621 CS-01 Before

701 (DH) - CS-01 Before

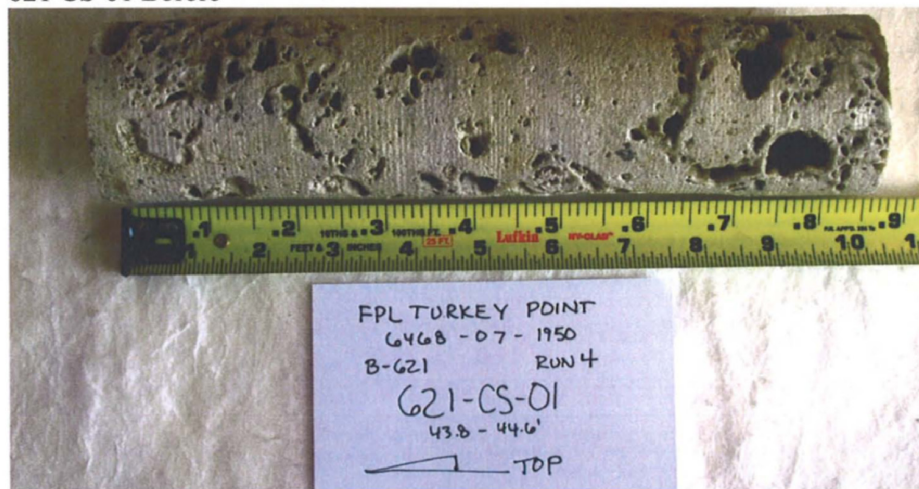
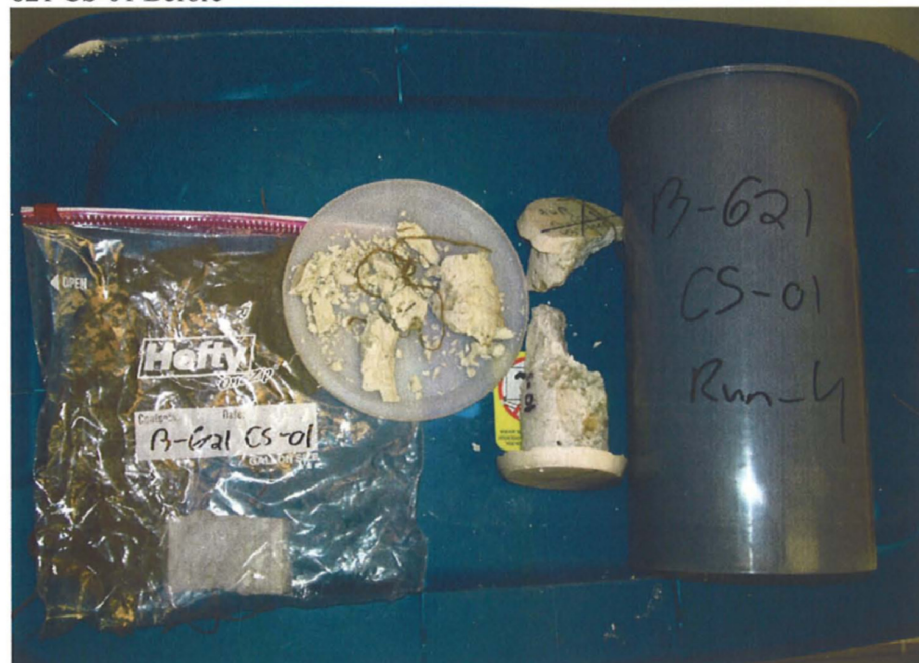
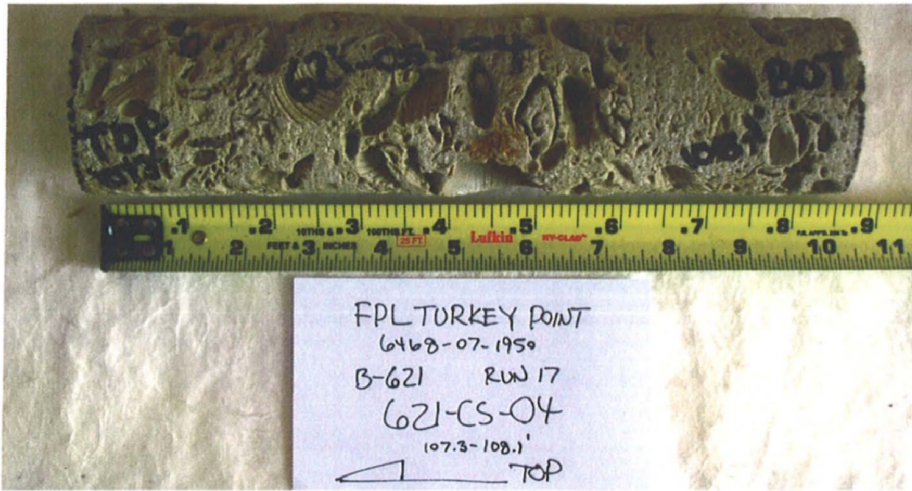
621 CS-01 After

621 CS-04 Before

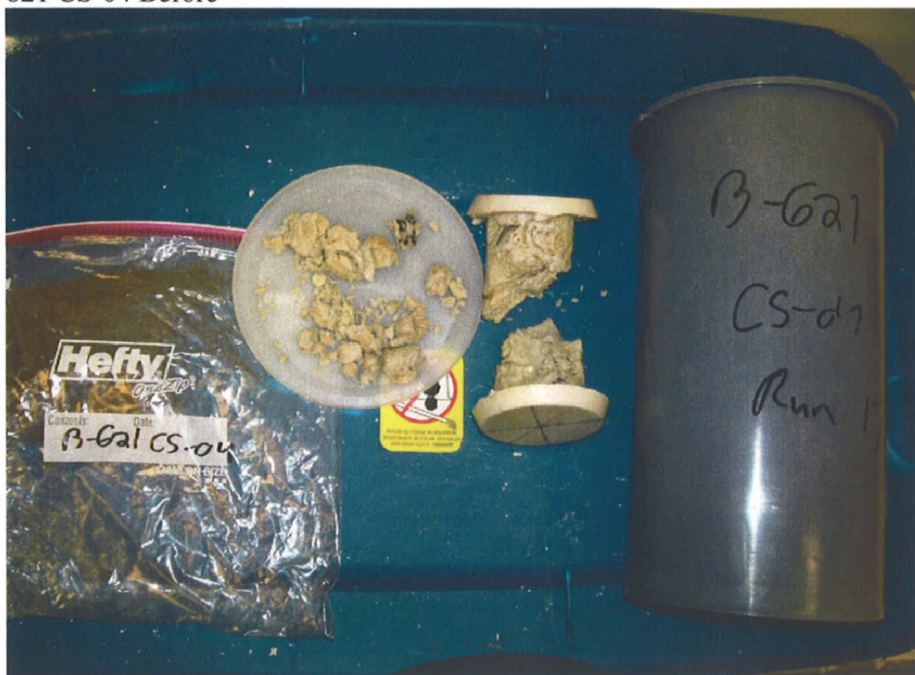
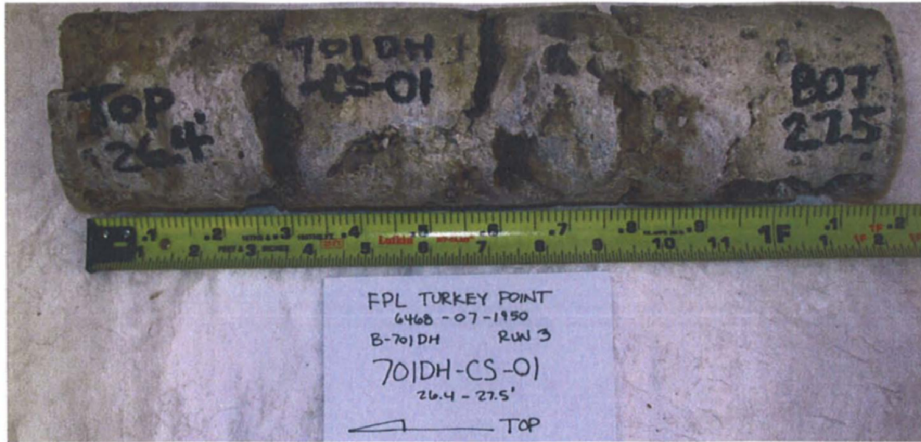
621 CS-04 After

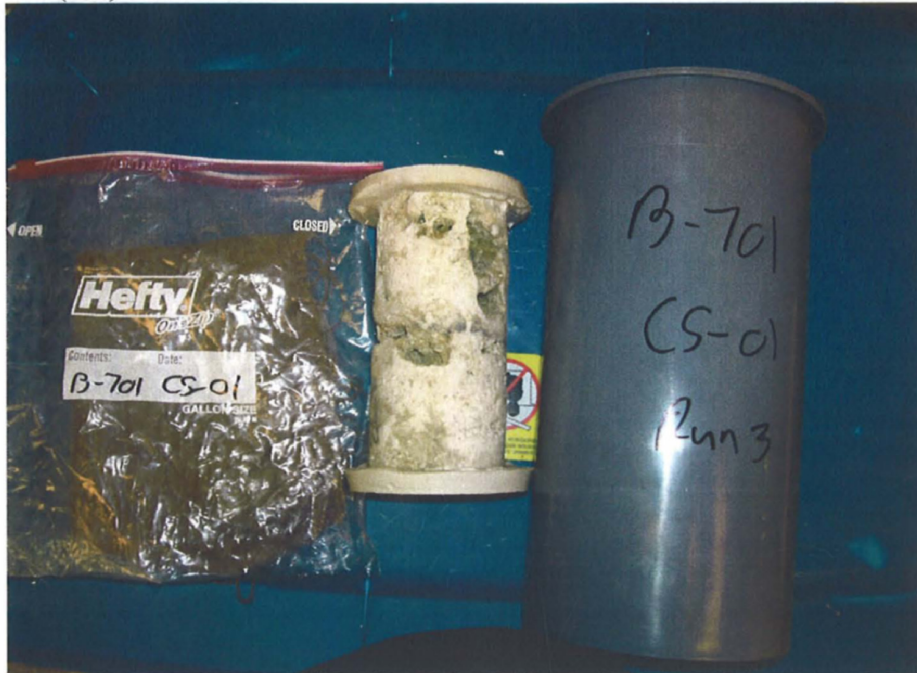
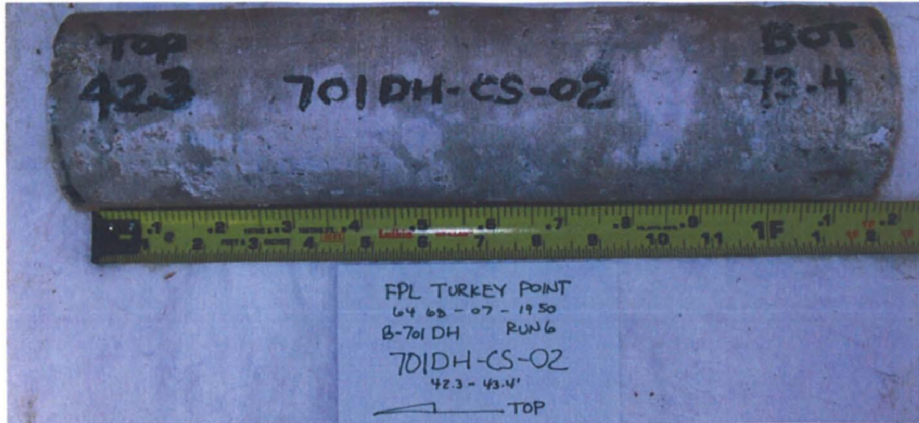
701 (DH) - CS-01 After

701 (DH) - CS-02 Before

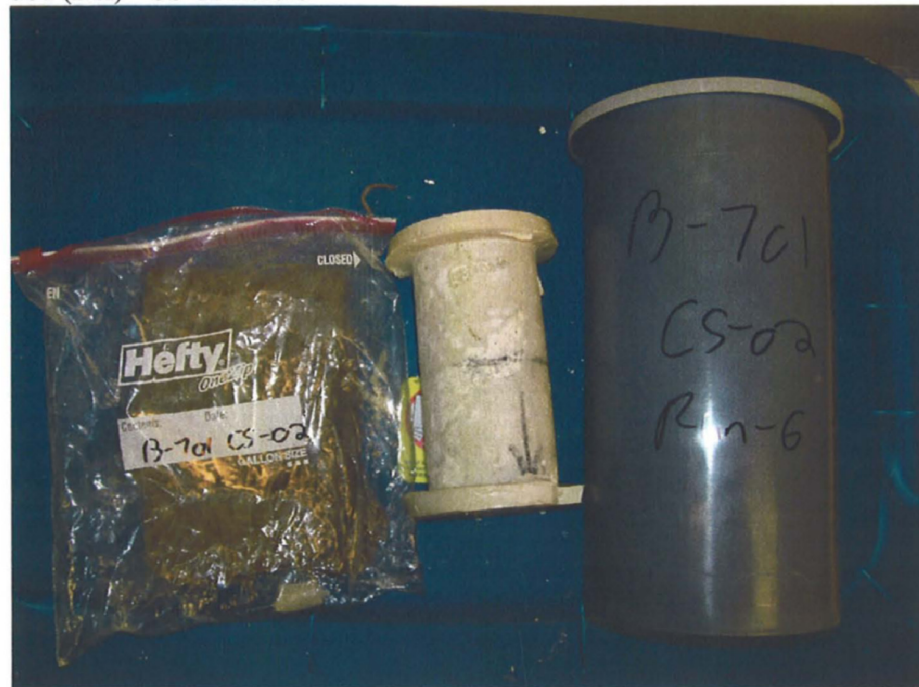
701 (DH) - CS-02 After
